STAFF REPORT  
(Final Plat)

**CASE NUMBER:** S/D 96-81 - SUMMERFIELD 3RD ADDITION

**LOCATION:** North of 21st Street North and east of Rock Road

**VICINITY MAP:**

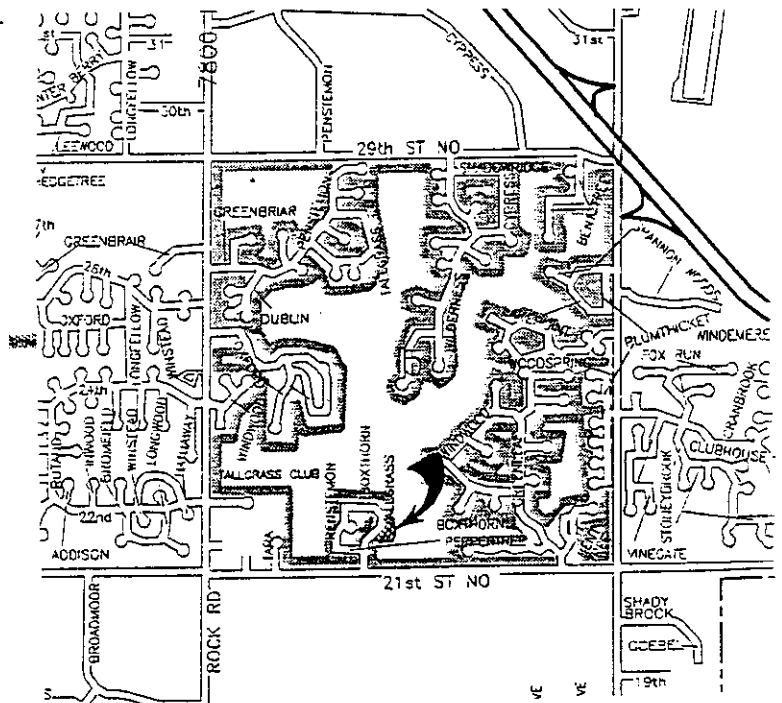
*Add min. pad on text*
